PLANNING COMMISSION MEETING AGENDA

A. Parr Lumber Tentative Subdivision Plan

**REVISED PLANNING DEPARTMENT FINDINGS OF FACT
AND CONCLUSIONS OF LAW
File No.: SUB-24002**

**Before the City of Central Point Planning Commission
Consideration of a Tentative Plan for Parr Lumber Replat**

Attachment “B” – Tentative Subdivision Plan

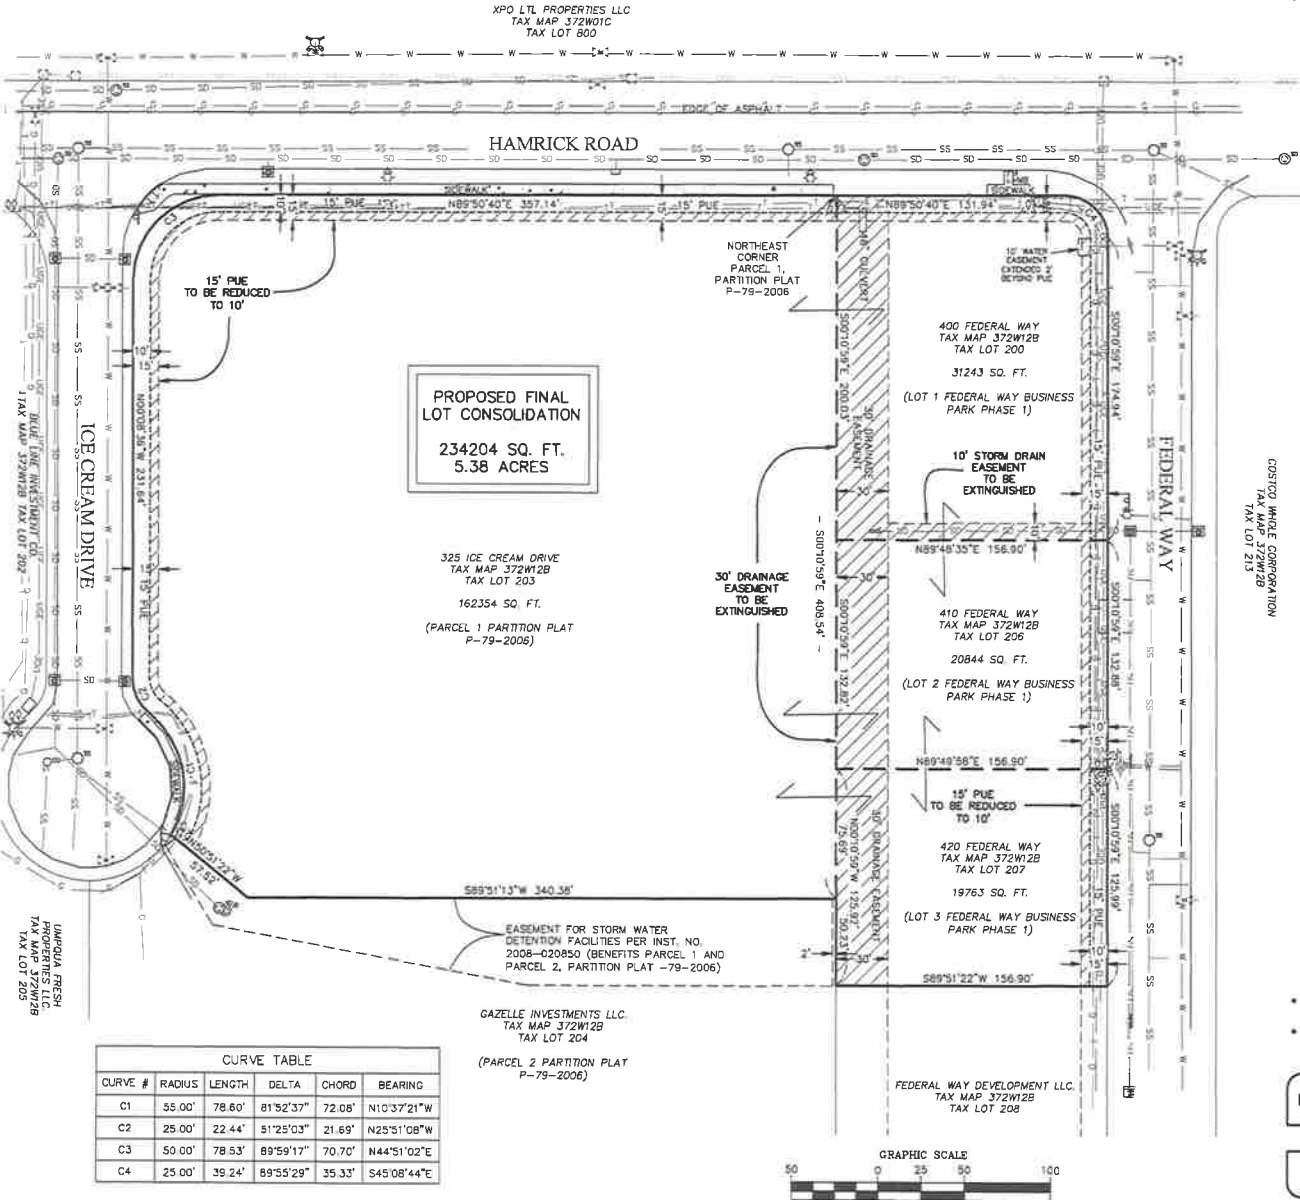
In review of the application, it was noted that there is an existing drainage easement along the western boundary of 400, 410 and 420 Federal Way. The drainage easement was created to provide an area to collect and convey stormwater runoff from the right-of-way of Federal Way and the lots within the Federal Way Business Park, Phase 1, subdivision.

The Applicant proposes to extinguish the easement due to conflicts between the location of the easement and the site development plan (Attachment “E”).

Comment: As noted in the Public Works staff report, the easement must be relocated to the property frontage along the west side of Federal Way and south side of Hamrick Road, immediately behind the existing Public Utility Easements. Staff recommends Condition of Approval No. 1(a) requiring a revised tentative plan that depicts the new location of the drainage easement.

Finding CPMC 16.10.050(B): *As shown on the tentative plan (Figure 1), there is an existing 15-ft Public Utility Easement (PUE) along the frontage of all public streets. As part of the application, the Applicant proposes to reduce the PUE width to 10-feet. A 30-foot drainage easement bisects along the western*

property boundary of 400, 410 and 420 Federal Way and the eastern property boundary of 325 Ice Cream Drive. The drainage easement provides an area for on-site retention and conveyance of stormwater runoff from the lots within the Federal Way Business Park and the Federal Way right-of-way. The tentative plan proposes to extinguish the storm drain easement. Conditions of approval in the Public Works Staff Report dated November 4, 2024, requires the Applicant to relocate the drainage easement to the property frontage along the west side of Federal Way and south side of Hamrick Road, immediately behind the existing Public Utility Easements.

Finding CPMC 16.24.030(B): *As shown on the Tentative Plan (Figure 1), the proposed subdivision is traversed by a drainage easement along the western property boundary of 400, 410 and 420 Federal Way and the eastern property boundary of 325 Ice Cream Drive. The drainage easement provides an area for on-site retention and conveyance of stormwater runoff from the lots within the Federal Way Business Park and the Federal Way right-of-way. The tentative plan proposes to extinguish the storm drain easement. Conditions of approval in the Public Works Staff Report dated November 4, 2024, require the Applicant to relocate the drainage easement to the property frontage along the west side of Federal Way and south side of Hamrick Road, immediately behind the existing Public Utility Easements.*

1. Prior to final plat approval, the applicant shall satisfy the following conditions:
 - a. Submit a revised tentative plan that depicts the relocation of the existing storm drainage easement to the west side of Federal Way and the south side of Hamrick Road behind the Public Utility Easement, interior to the site.

SITE PLAN

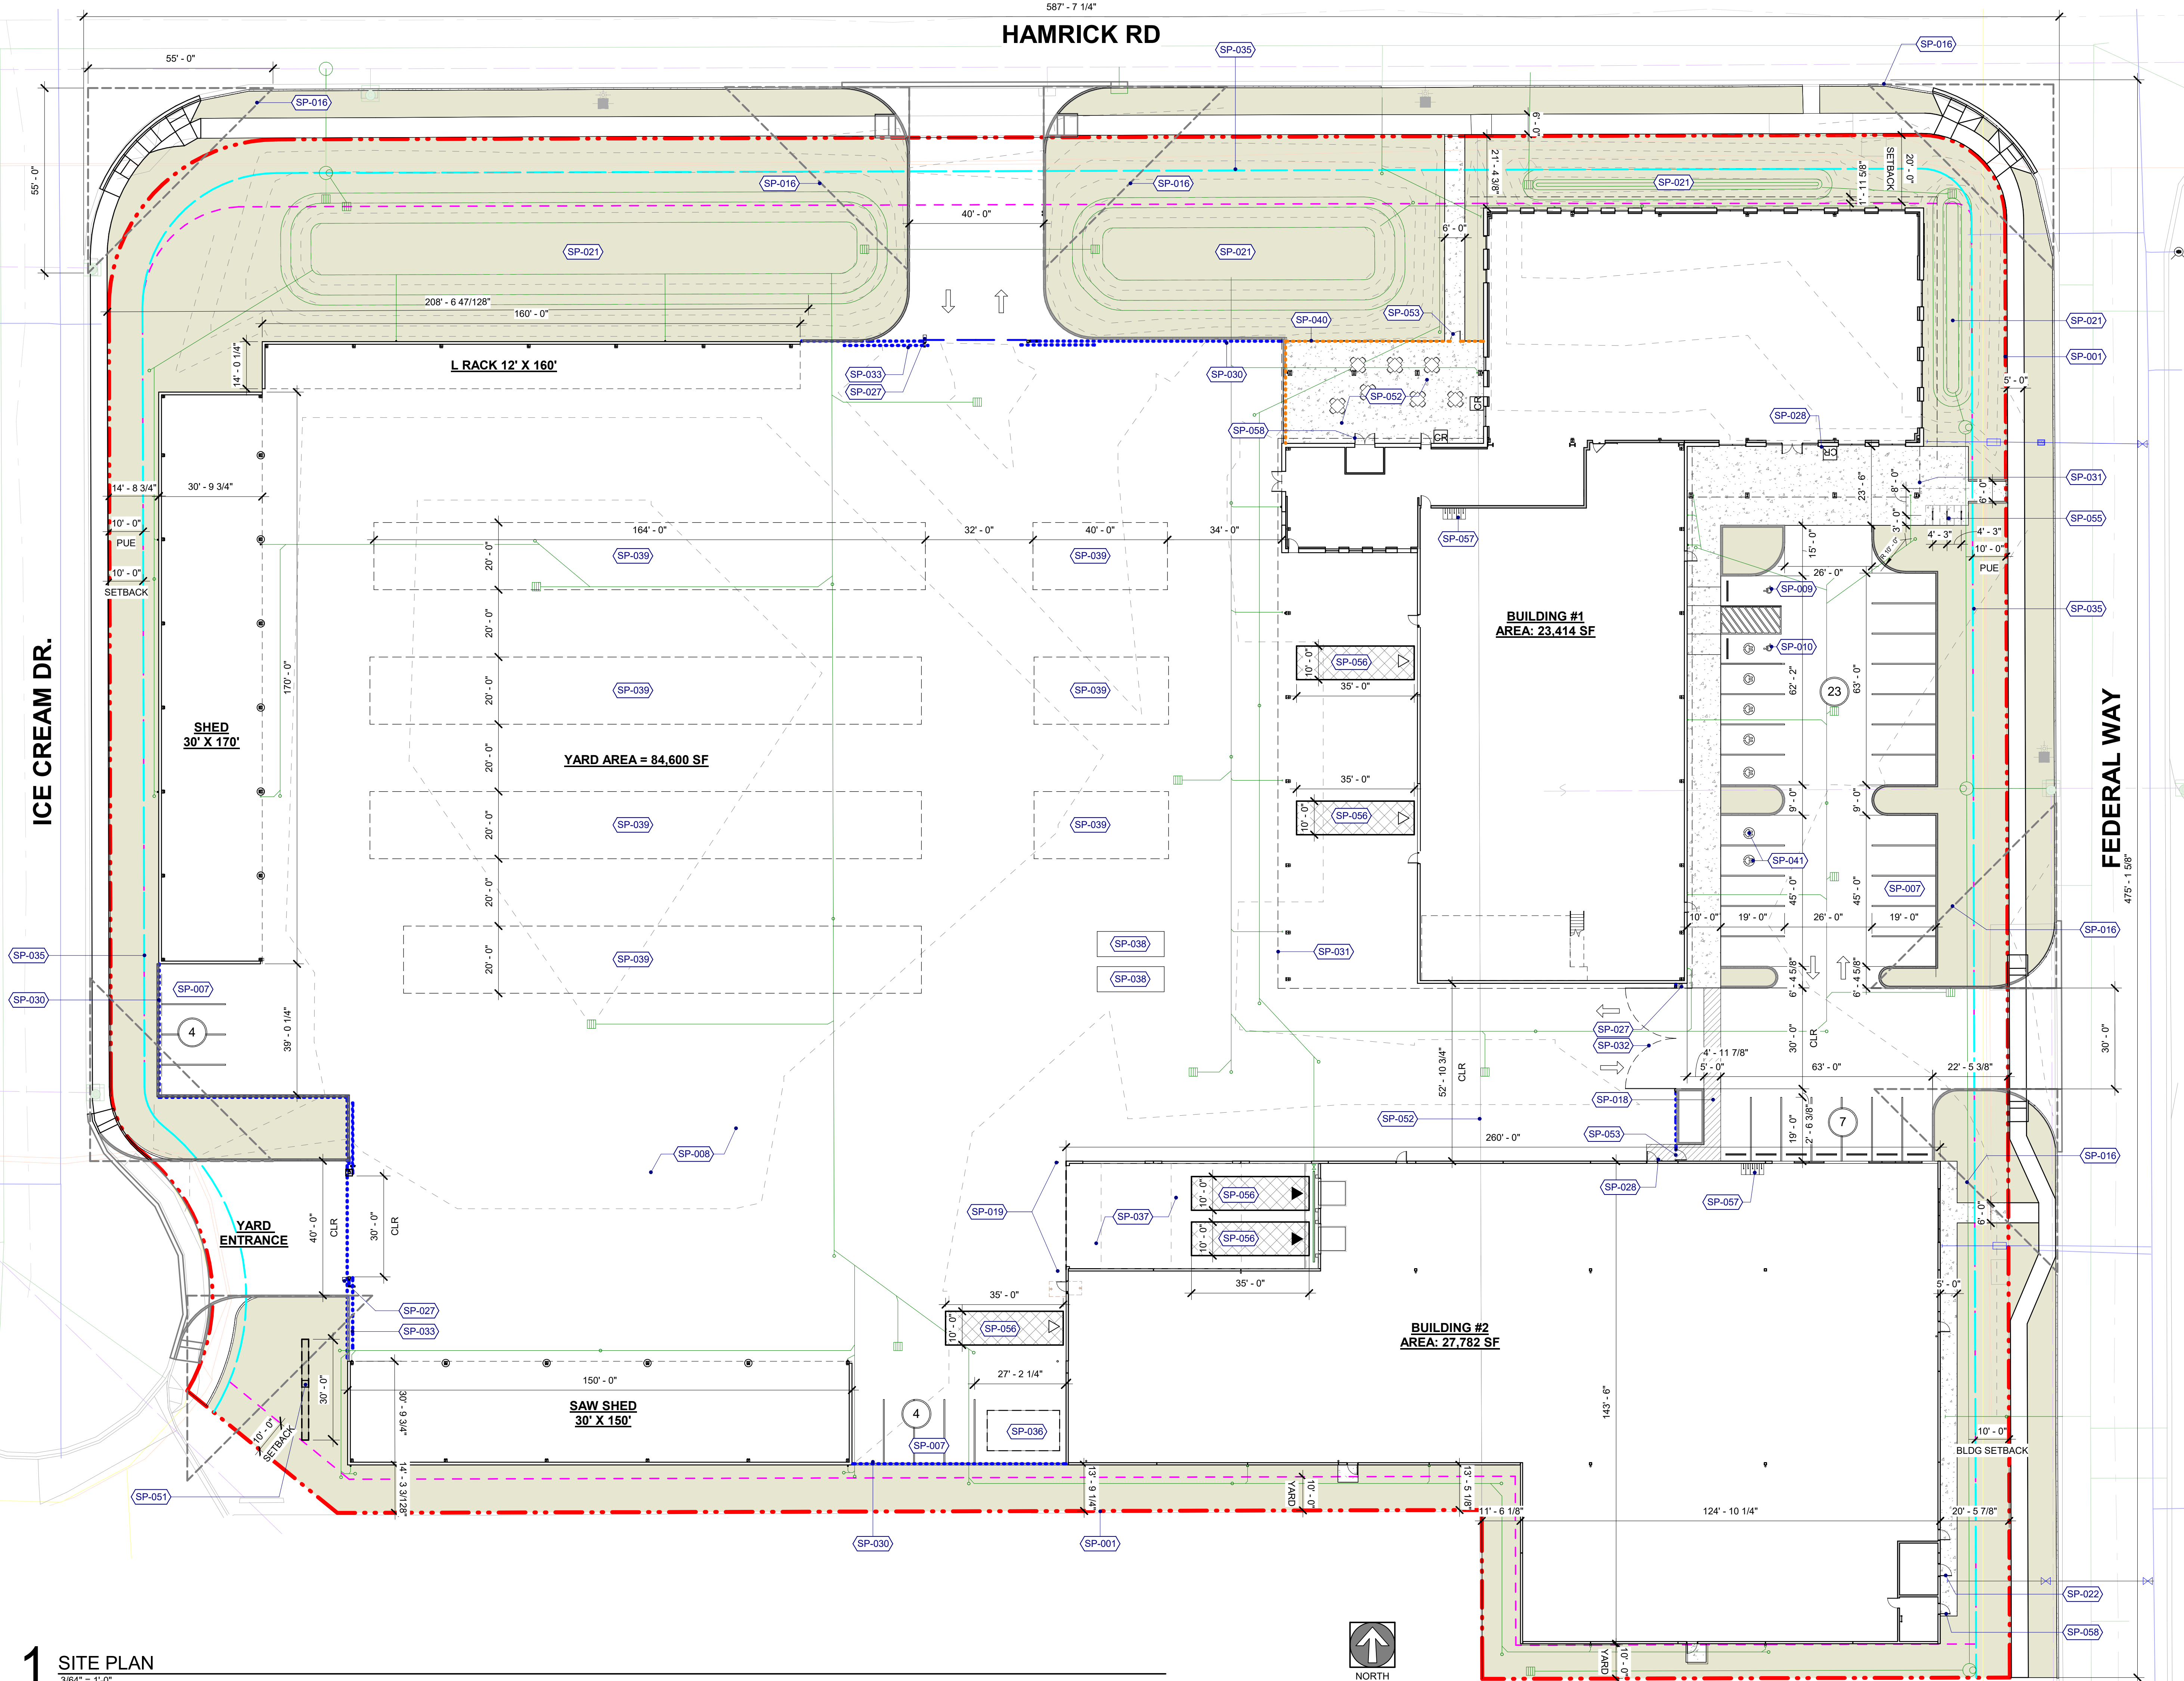
Finding CPMC 16.20.130: As shown on the Approved Site Plan (Figure 3) sidewalks are proposed along all street frontages of the subject site. Per the Public Works Staff Report dated November 4, 2024, sidewalk design must be approved by Public Works staff prior to building permits and installation completed prior to final inspection.
